Project	<b>IEEE 802.16 Broadband Wireless Access Working Group</b> < <a href="http://ieee802.org/16">http://ieee802.org/16</a> >	
Title	<b>SS - Initial Ranging</b>	
Date Submitted	<b>2001-03-07</b>	
Source(s)	Antonis Karvelas Intracom S.A. 19002, PEANIA ATTIKA GREECE	Voice: ++3016690753 Fax: ++3016860329 <a href="mailto:akarb@intranet.gr">mailto: akarb@intranet.gr</a>
Re:	Letter Ballot #3	
Abstract	Replacement for Figures 80,81	
Purpose	Correct Figures 80,81.	
Notice	This document has been prepared to assist IEEE 802.16. It is offered as a basis for discussion and is not binding on the contributing individual(s) or organization(s). The material in this document is subject to change in form and content after further study. The contributor(s) reserve(s) the right to add, amend or withdraw material contained herein.	
Release	The contributor grants a free, irrevocable license to the IEEE to incorporate text contained in this contribution, and any modifications thereof, in the creation of an IEEE Standards publication; to copyright in the IEEE's name any IEEE Standards publication even though it may include portions of this contribution; and at the IEEE's sole discretion to permit other

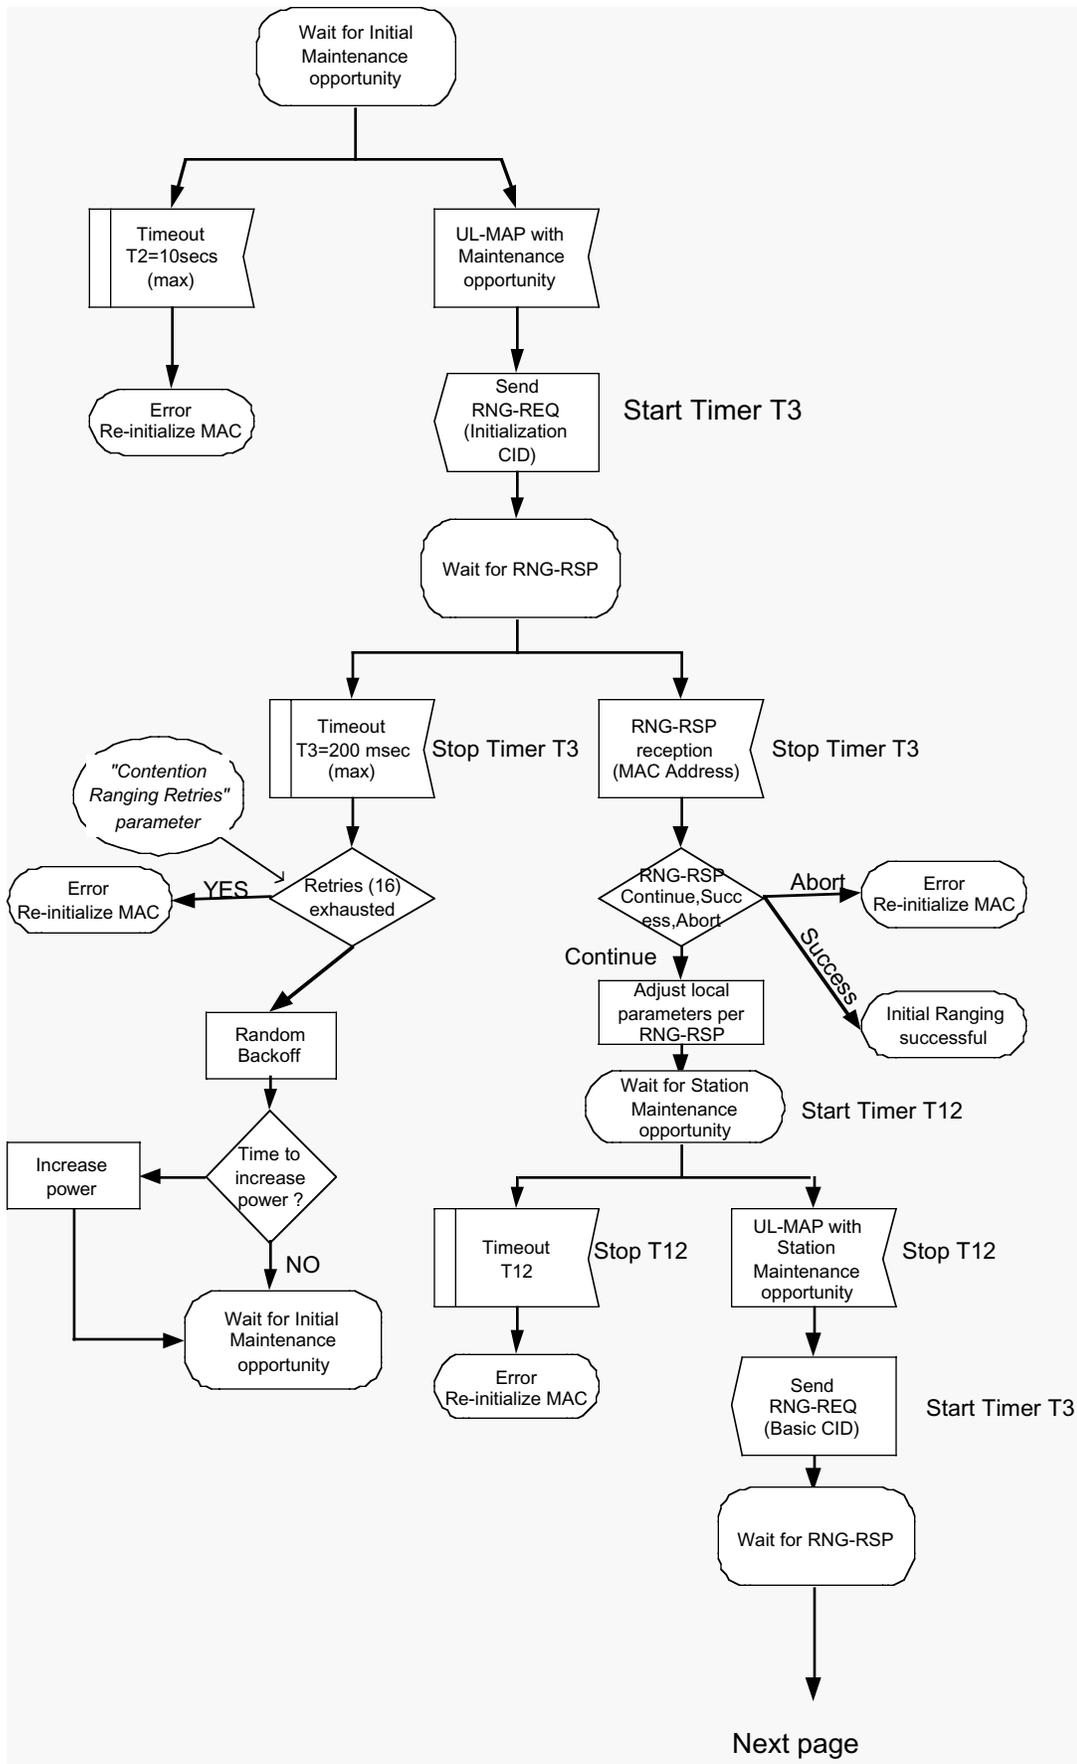
The above figure would be a replacement for Figure 80 as it gives a lot of details about the Initial Ranging mechanism of a SS.

Following the proposed replacement for Figure 81 :

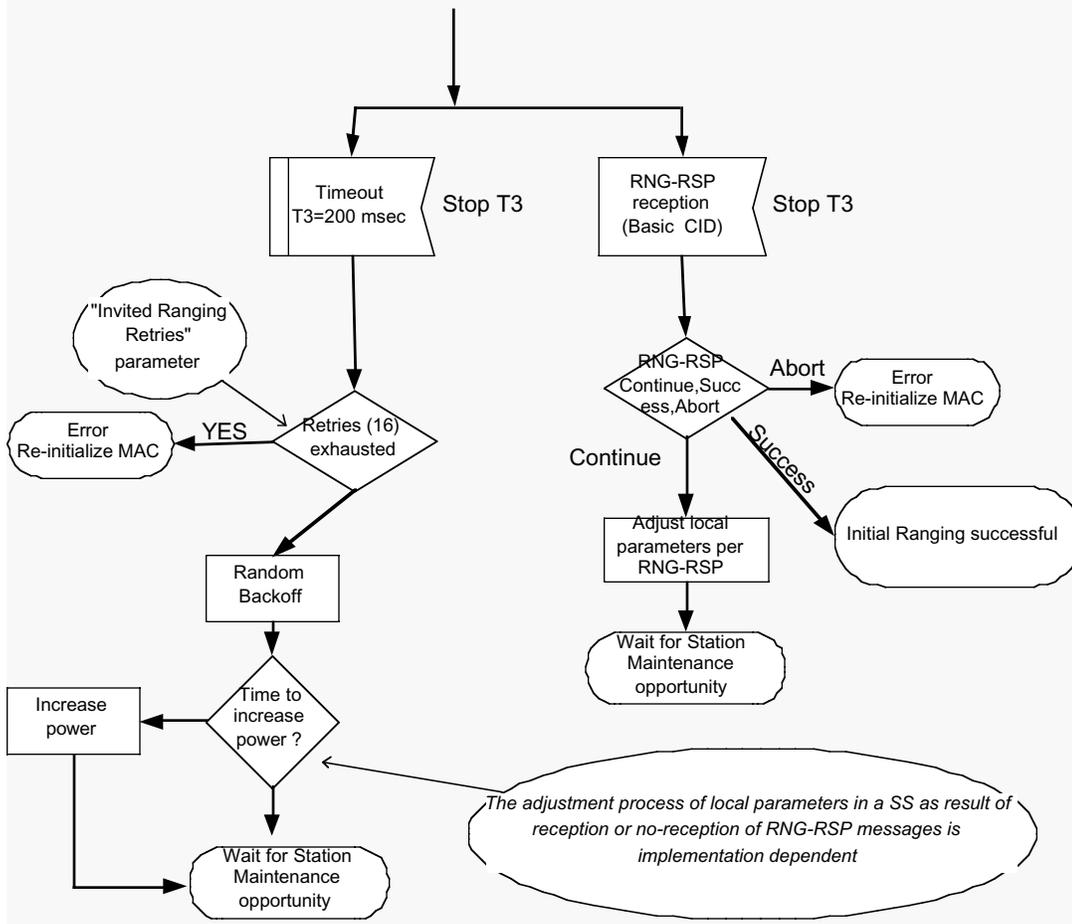
The above SDL diagram describes with detail the SS Initial Ranging process. Also introduces a new Timer the T12 Timer. This Timer 12 must be inserted in the Table 67 with the name “T12” and Time Reference “Wait for unicast ranging opportunity during Initial Ranging”.

Also the above SDL diagram shows the time at which the various timers are created and destroyed during the Initial Ranging process.
